Staff Report to the Planning Commission

Application Number: **06-0290**

Project Description: This is a proposal to divide an approximately 14,600 square foot parcel with an existing single-family dwelling into two parcels, construct a new single-family dwelling and an over-height fence in the front yard of the back parcel, and create a less than 40-foot wide right-of-way to serve both parcels.

Location: The property is located approximately 400 feet east of 17th Avenue on the south side of Alice Street in the Live Oak Planning Area (1832 Alice St.)

Grading and Driveway Improvement Plan

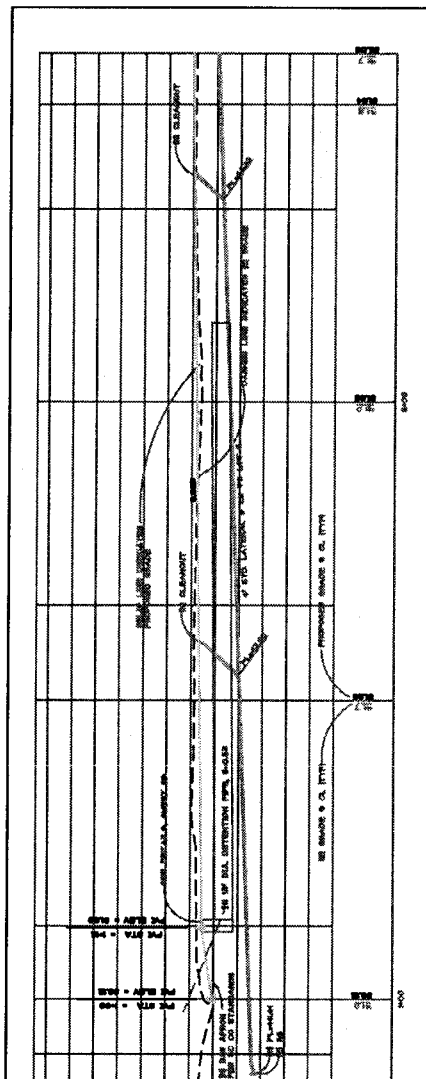
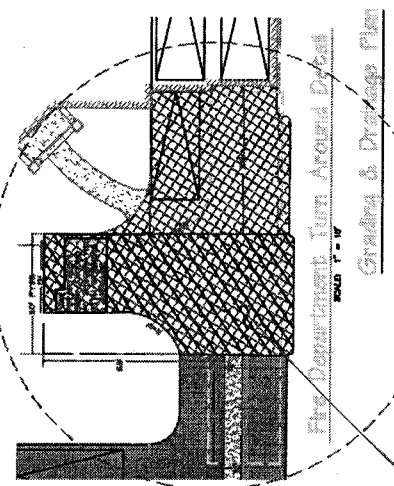
1) Provide proposed contours on sheet P2 consistent with the proposed drainage plan.

4. The Drainage plans shall provide proposed contours on Sheet P2 consistent with the proposed drainage plan.
5. The drainage plan shall address whether the hard piping of roof run-off on the north side of the garage from parcel B can be eliminated to allow discharge of runoff over the paver section.
